## STAFF REPORT FOR THE PLANNING COMMISSION

**FILE NUMBER:** DR-12-08/VAR-12-01

**REQUEST:** Class II Design Review approval for construction of a 4,335 square foot Chase Bank Branch with parking and remote three-lane drive through at the rear of the building and a Class II Variance from the transparency (window) requirements on the front and side elevations.

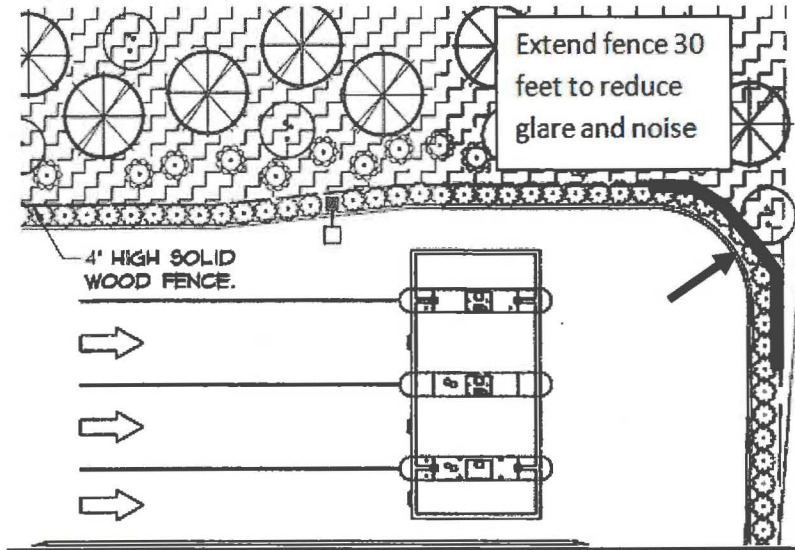
4. Fences. The southerly end of the four-foot high wood fence to the east of the drive through ATM lanes, depicted on Exhibit PC-3, Sheet L1 shall be extended 30 feet to reduce glare, generally as depicted below:

#### **FINDING 4:**

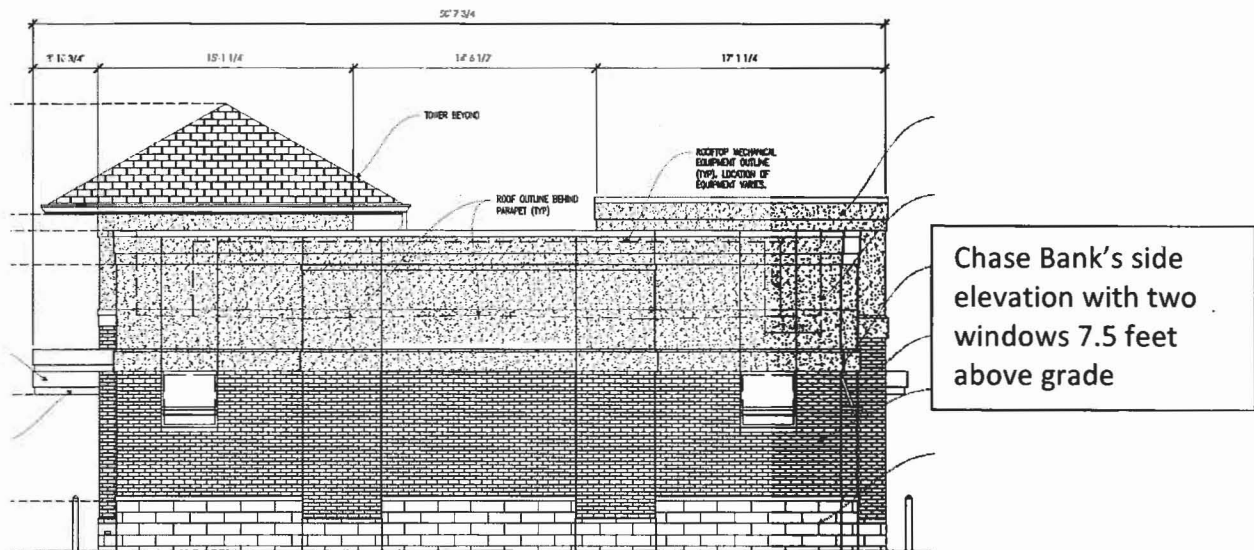
The applicant does not meet the front transparency requirement of 60%. Only 42.1% of the front elevation has windows at pedestrian or eye level. Four clerestory windows on the front elevation are too high to contribute to the transparency requirement. But even if they were included, the amount would fall short. The two side elevations are both visible from Willamette Drive so both must meet the 30% transparency requirement. The two side elevations have no windows at pedestrian or eye level so their 0% percent transparency is well short of the required 30%. Consequently, the applicant has applied for a Class II Variance. See Finding 8 below.

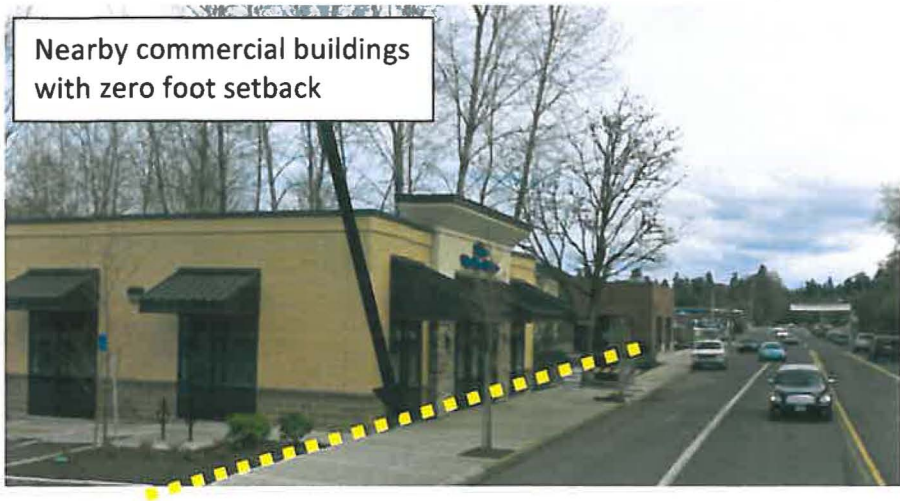
The applicant was advised by staff that the bank should be built on the edge of the Willamette Drive right-of-way per this approval criterion and the following reasons:

- the building can offer amenities for passersby in the form of awnings which provide shelter from rain and sun,
- a focused activity area in front of the building creates opportunities for social interaction between people on the sidewalk and in the businesses (through the pedestrian level windows),
- as buildings are built closer to the street, pedestrian level windows offer visual interest or visual snags for passing pedestrians and motorists,
- as buildings “crowd” the street, the narrower field of vision along Willamette Drive encourages slower and safer vehicle speeds.

**FINDING 8:**

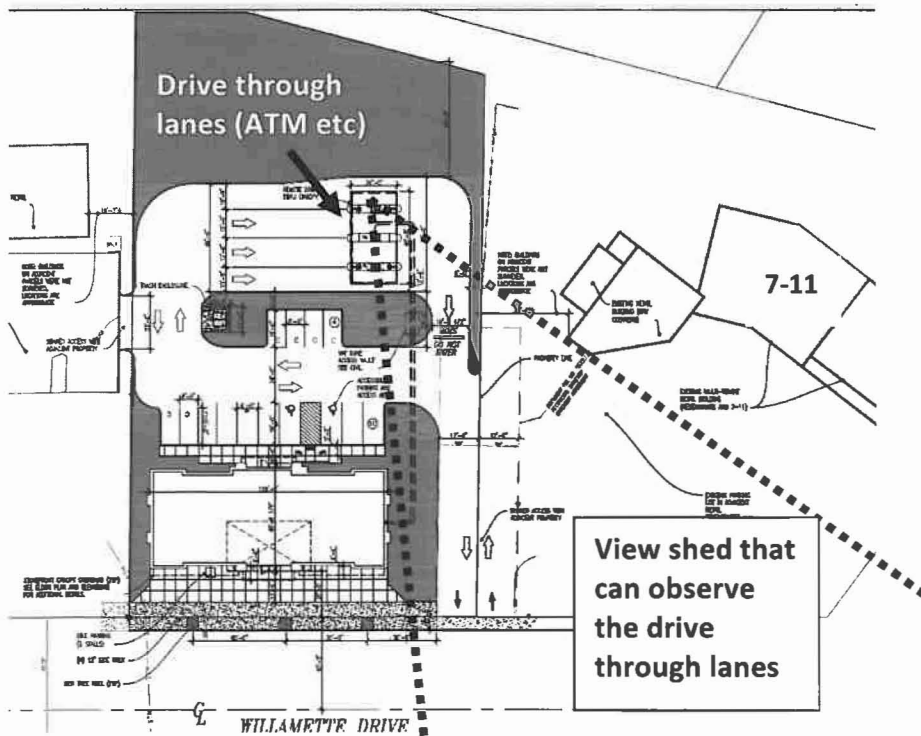
Staff's concern is surveillance of the drive through lanes at night time. Specifically, can the drive through lanes be readily observed from Willamette Drive or nearby activity areas? Staff finds that with the lines of sight to the south through the 7-11 parking lot and along the entry driveway, the answer is yes. The proposed security lighting also helps.

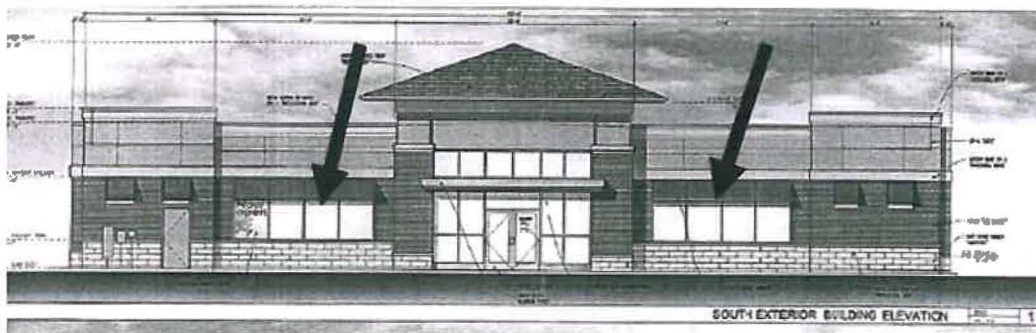
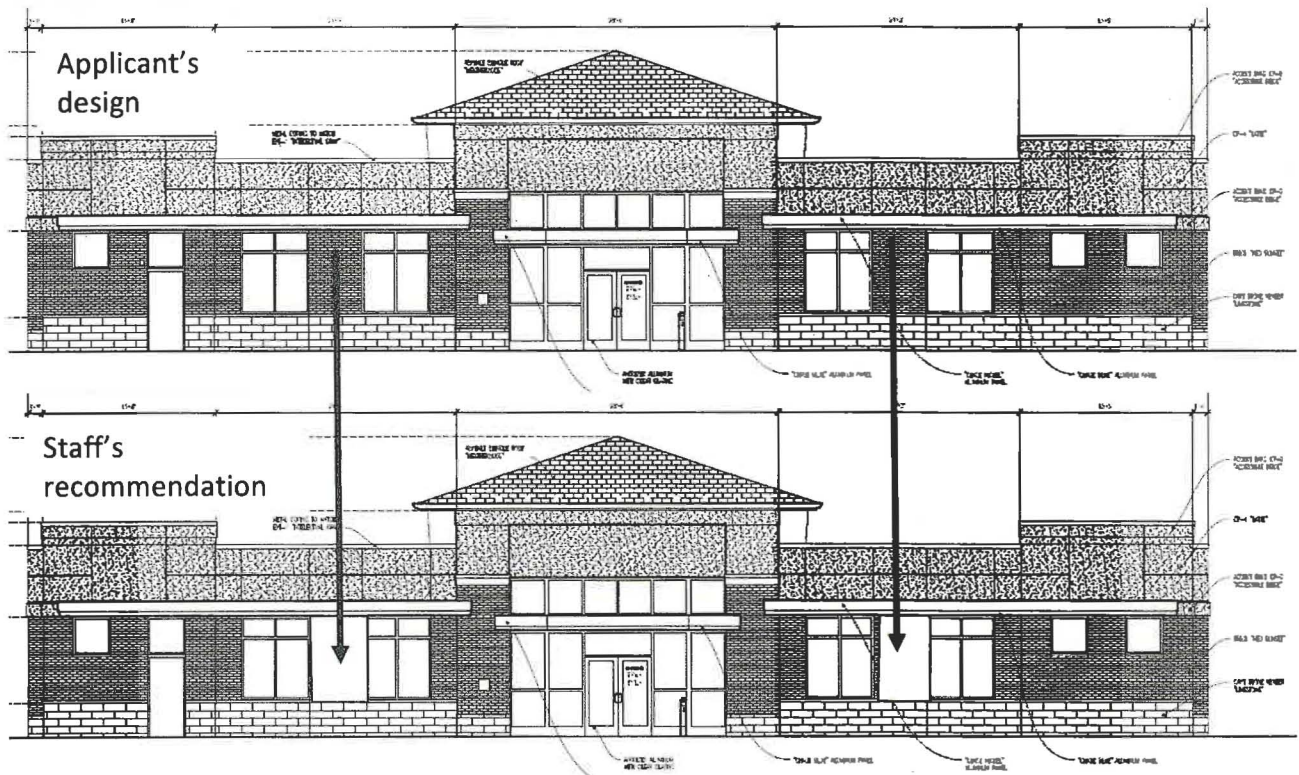
The most compelling evidence demonstrating that more windows could be added is that Chase Bank's architects (Callison Architects) submitted virtually the same building and elevation designs to the City of Portland and the Hillsdale Neighborhood Association in 2011 but with more windows along the front elevation (see the following illustrations). According to the applicant's calculations (page 4 of the 04/12/12 submittal) the front elevation is 102 feet long and the proposed transparency comprises 43 feet 4 inches which translates to 42.4% transparency. If the Hillsdale version can have more transparency, then West Linn's version should be able to as well.

Contrast the proposed West Linn version (above) with the Hillsdale version (below).

Adding nine feet of windows on the front elevation, which would be similar to the Hillsdale Chase Bank proposal, would increase transparency to 51.2%; still shy of the required 60%, but an improvement. Staff recommends approval of the variance with the condition that the transparency be increased as indicated in the drawings below and per proposed Condition of Approval 3.

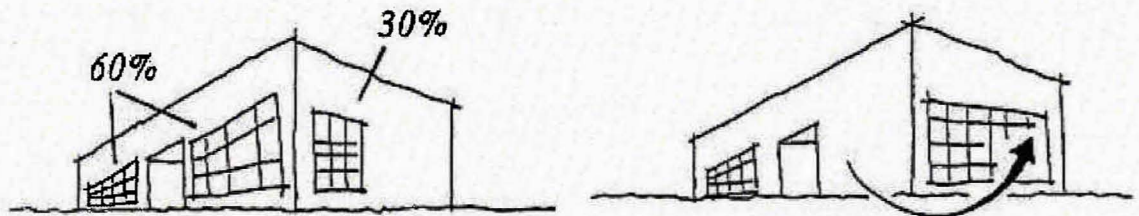
55.100(B) (3) requires that the topography and natural drainage shall be preserved to the greatest degree possible. The applicant needs to discuss the ten foot difference in grade at the rear of the site and what kind of grading will take place in this sloped area.

**This requirement appears to have been created in order to limit impact of development on undeveloped lands and their drainage patterns. The site was home to a nursery and the majority of this site has already been impacted by previous development. The front half of the site slopes gently away from Beaverton-Hillsdale Hwy and then slopes downhill more steeply along the north and south sides of the existing Kasch's Nursery building. The existing building itself is stepped to**
